System Pillar / EULYNX

Baseline Set 4 Release 2

Version: 2.3
Date: 13-12-2024

Error corrections

Msg_Ability_To_Move_Point used (corrected).png

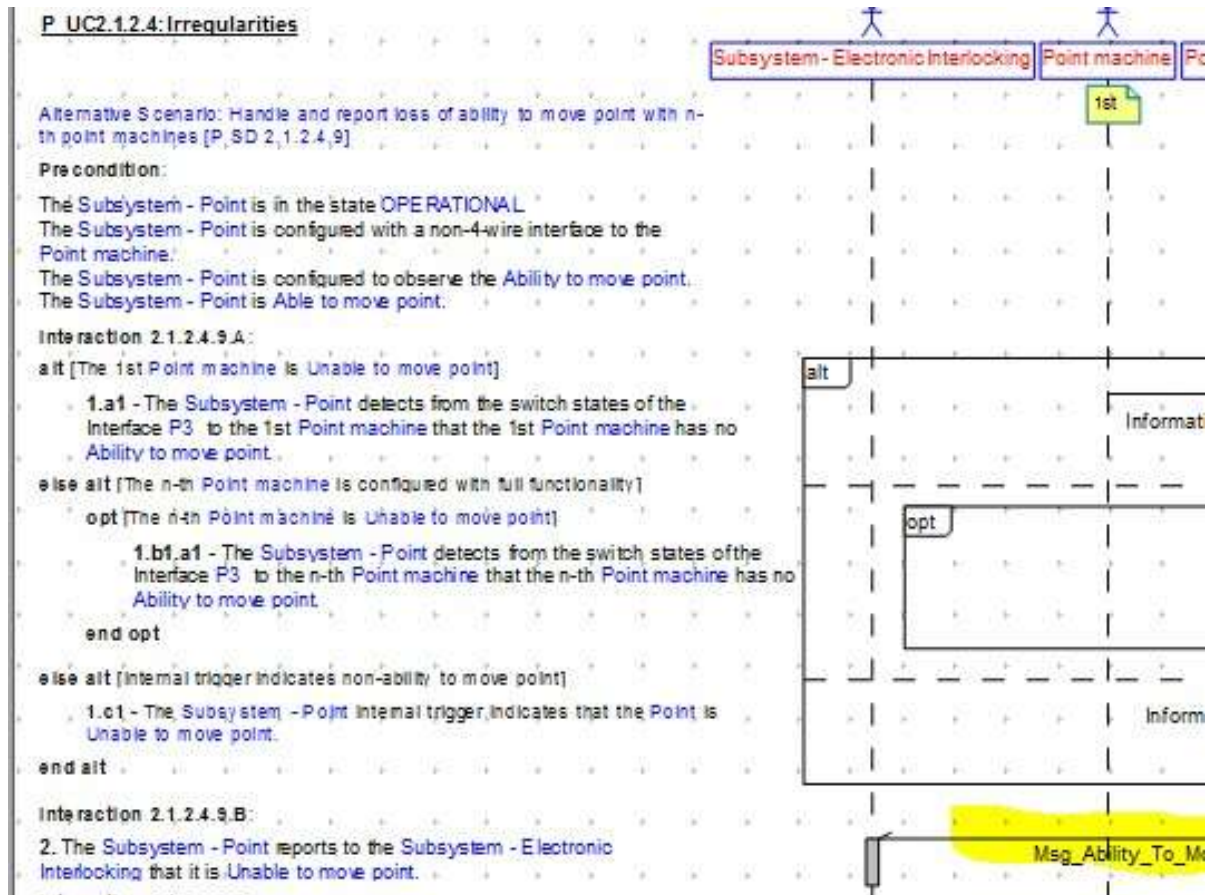
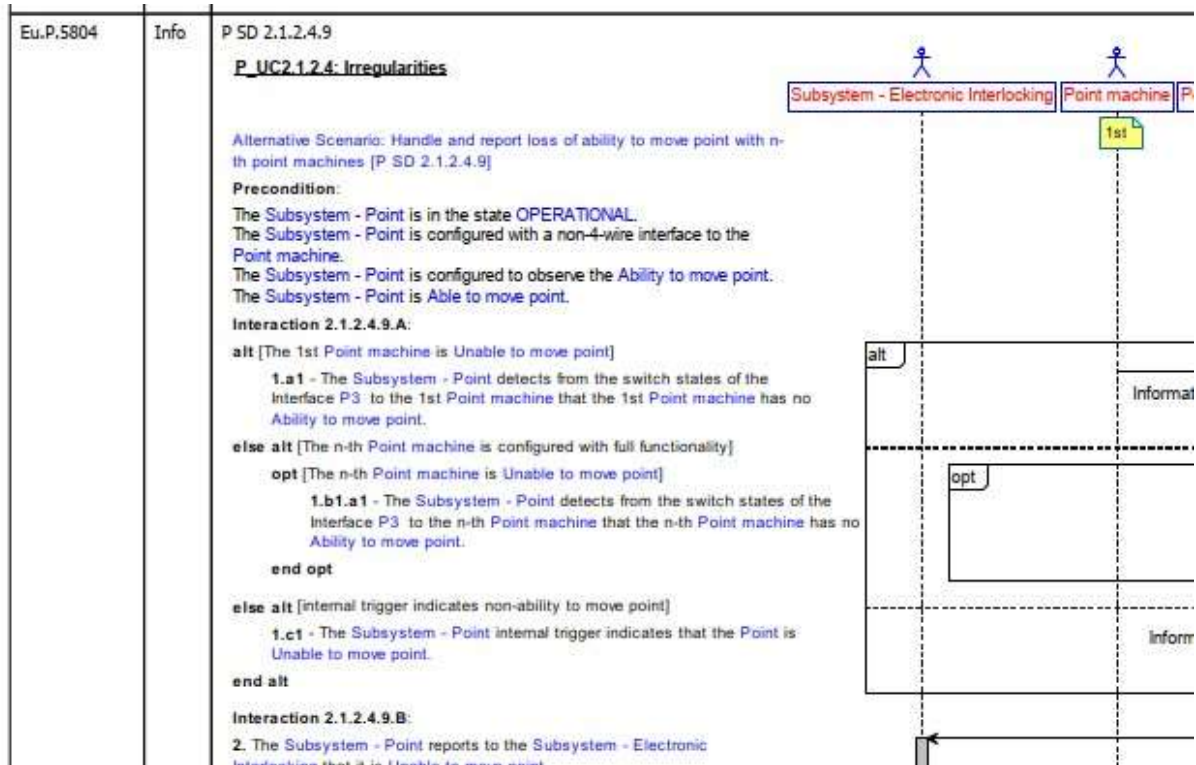
On SD 2.1.2.4.9 (Eu.P.5804) and 2.1.2.4.10 (Eu.P.5374) in on Step 2 a incorrect IO Flow is used (Msg_Point_Position).

Msg_Ability_To_Move_Point should be used.

image-2023-08-15-13-44-53-576.png

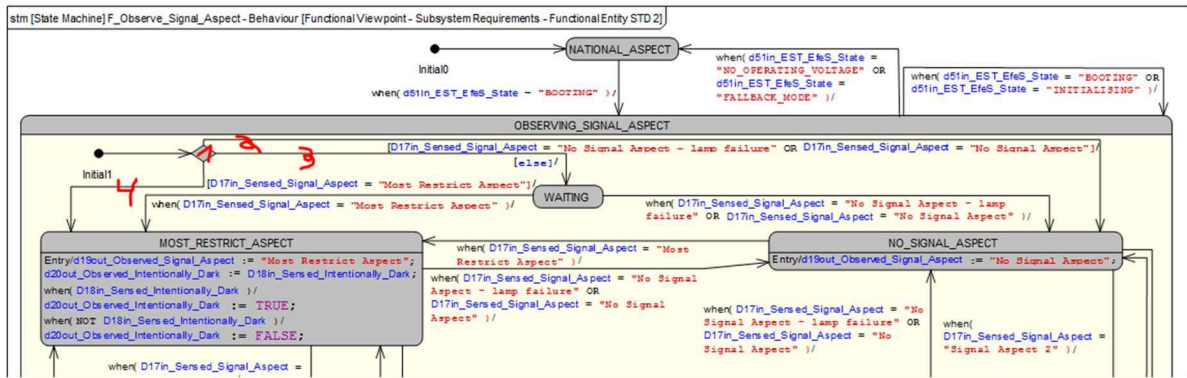
When the LS will be set from OPERATIONAL (while indicating "most restrict Aspect" back to BOOTING and then back to OPERATIONAL the controller is not able to report the newly set Aspect to the interlocking.

This is caused due to a deadlock in the observing block as it reacts just on the change trigger of D17 and can therefore not leave the state WAITING.

The STM for observe Signal Aspect shall be extended with transitions made of purely guard conditions (reacting on current state and not change trigger) as in attached pic shown. The four marked transitions/elements should be added to correct the described behaviour above.

F_Control_4W_PM

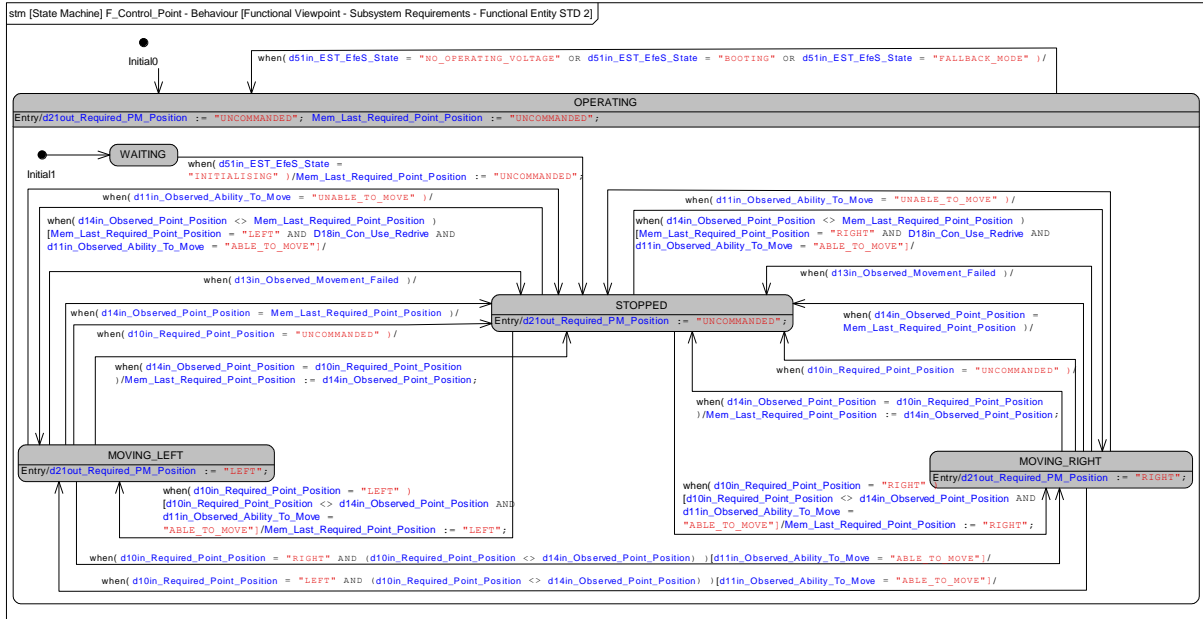
The correct transition must be `d27in_4W_PM_Position = "LEFT_REACHED" / d27in_4W_PM_Position = "RIGHT_REACHED"`.

The correct transitions are shown in the attached figure.
